From: [REDACTED]
To: [REDACTED]
CC: [REDACTED]
Sent: 2/25/2021 4:44:16 PM
Subject: RE: O8W-PM [REDACTED] - Bucks Creek 1101 Phase 1,2&3 - Pre-Engineering Meeting

Bucks Creek 1101- PM# [REDACTED] Overview Map

Subject: O8W-PM [REDACTED] Bucks Creek 1101 Phase 1,2&3 - Pre-Engineering Meeting

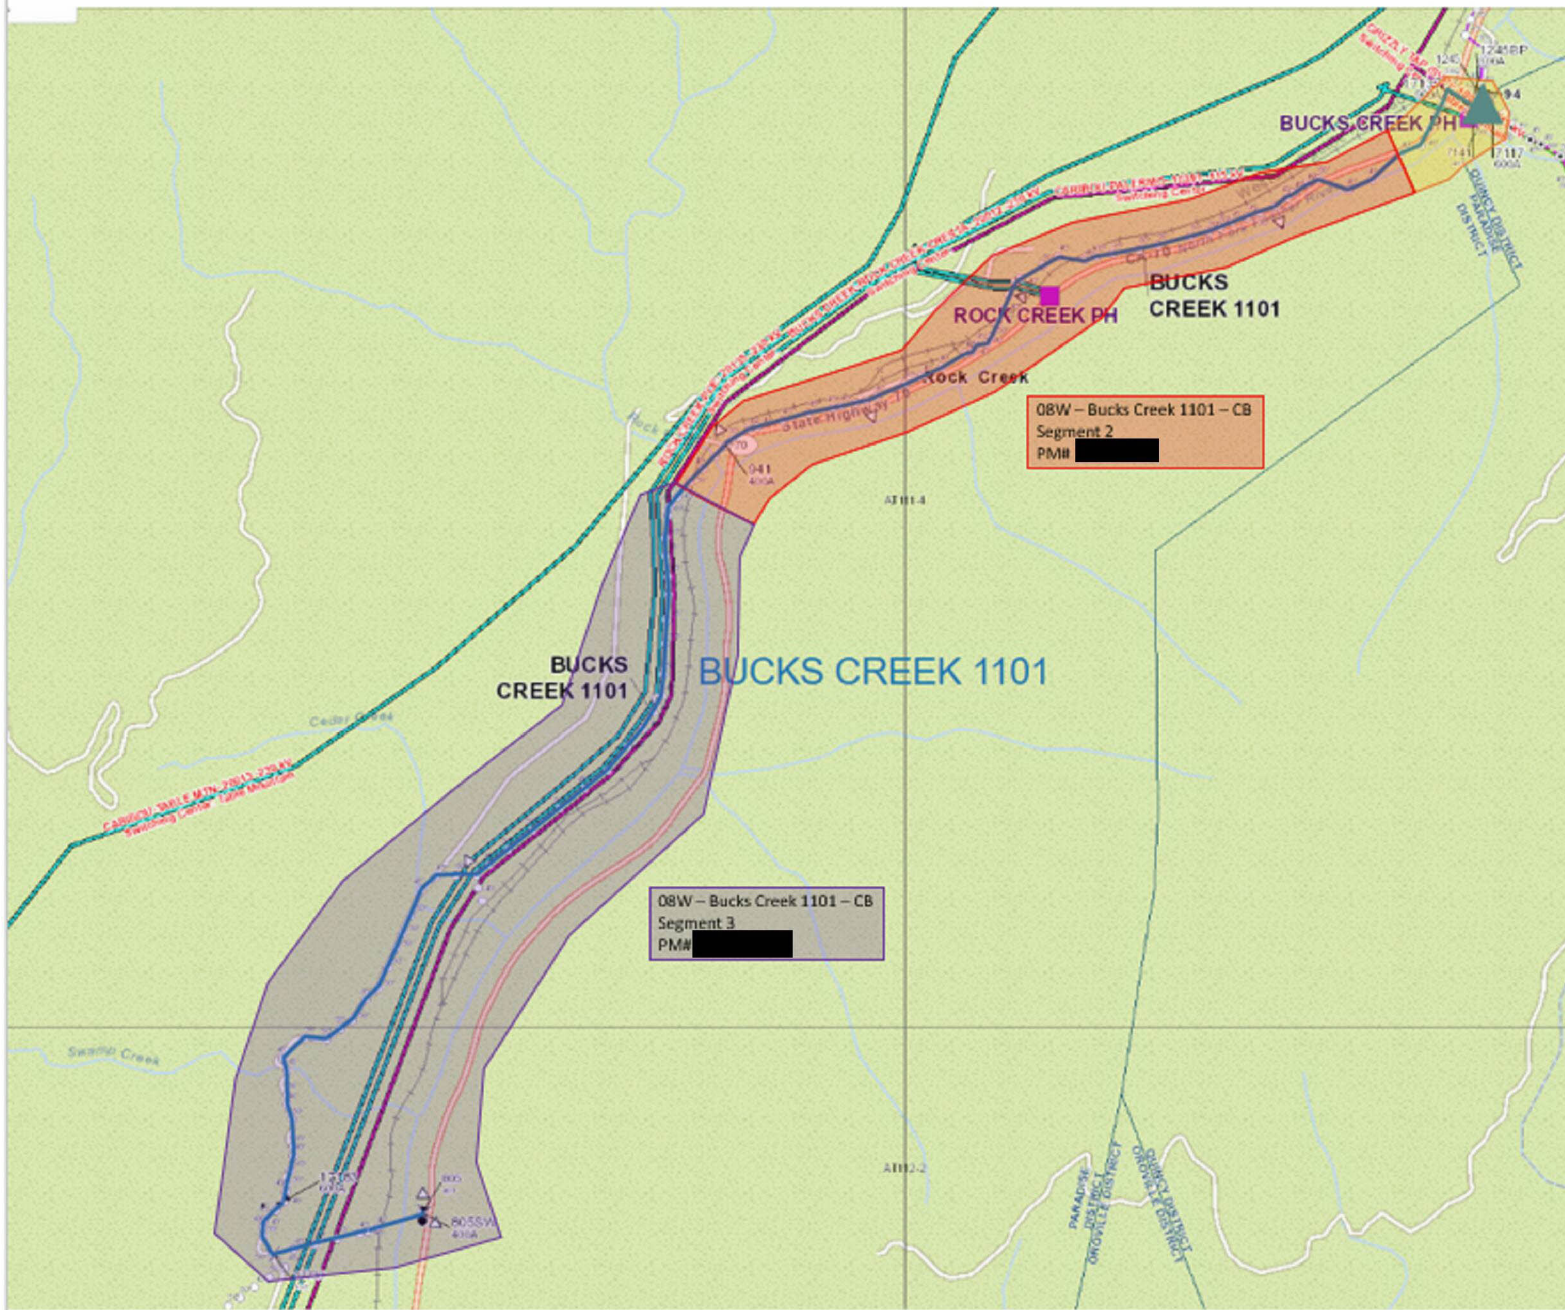
For Bucks Creek there is quite a bit of work surrounding Hwy 70 and we will need a Land Department Base Maps prepared for all 3 Orders. This will delay the EOD dates until these can be developed and provided to the Vendor... We will also need answers to the questions outlined by [REDACTED] below...
